FINAL DRAINAGE PLAN

THE RIDGE AT LORSON RANCH

FILING NO. 1: SF 22-004

JANUARY, 2022
REV. MARCH, 2022
REV. JUNE, 2022

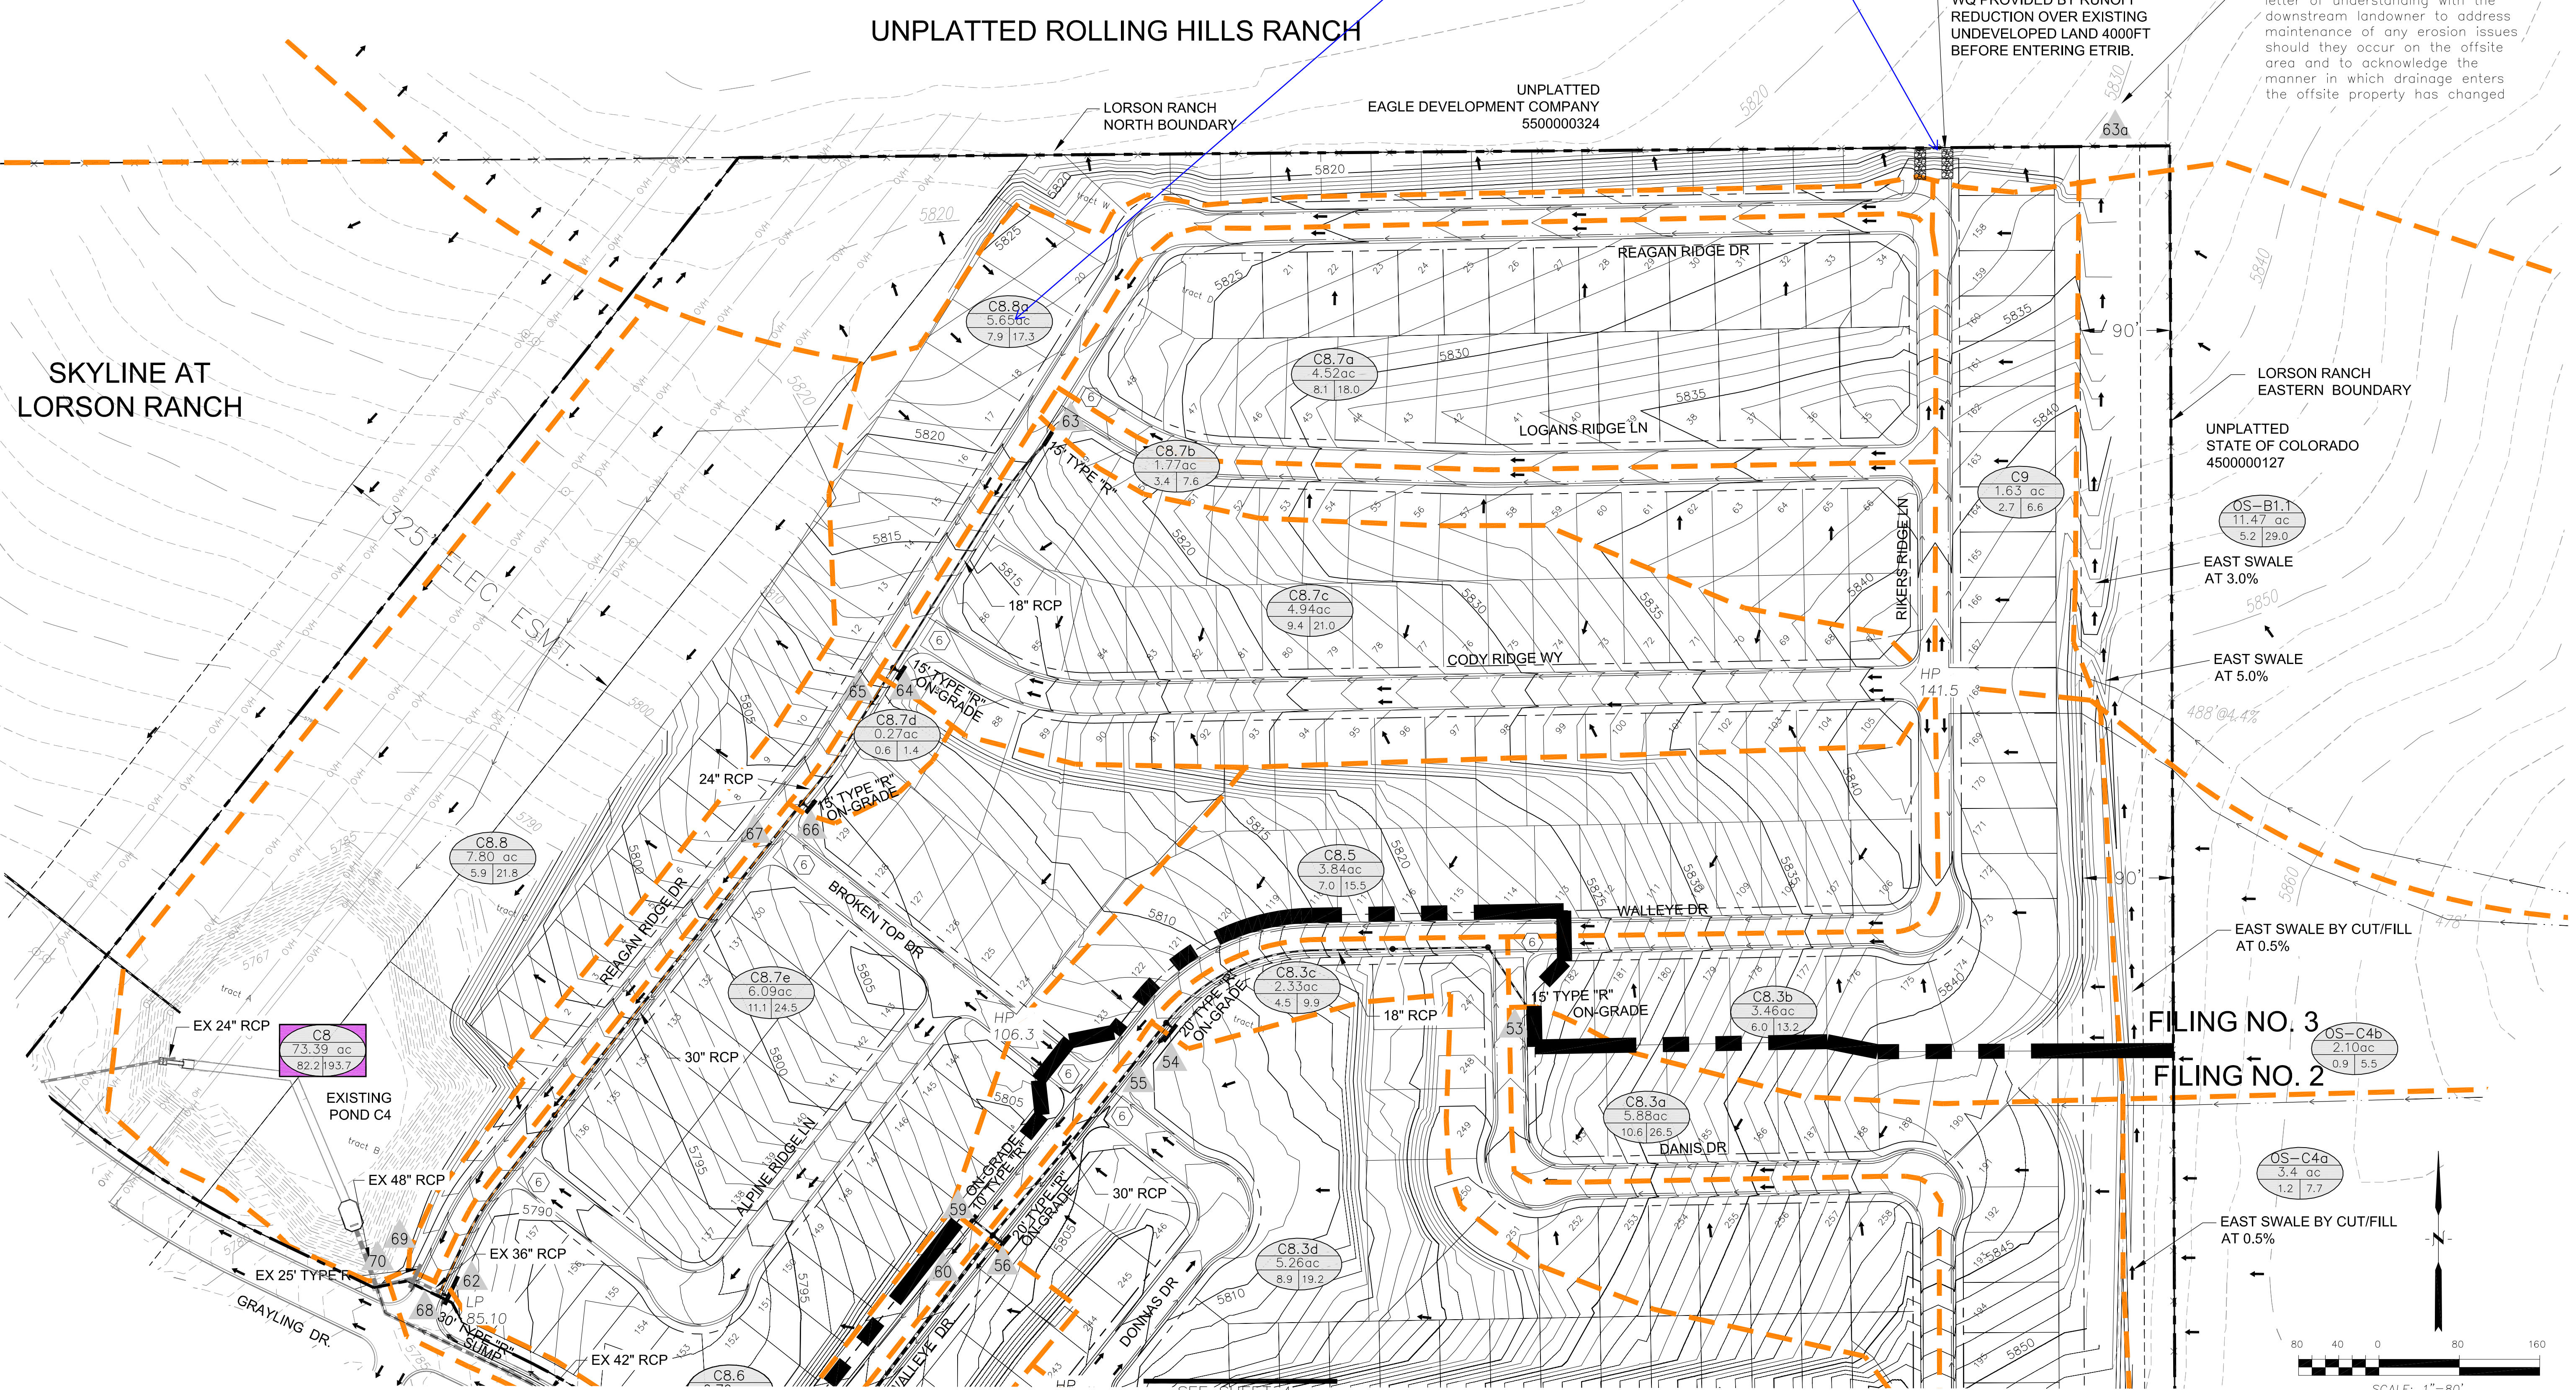
This acreage is too large to discharge offsite untreated and needs additional facilities. It would be logical to install the curb and gutter as previously shown and then remove it once the offsite downstream improvements have been constructed.
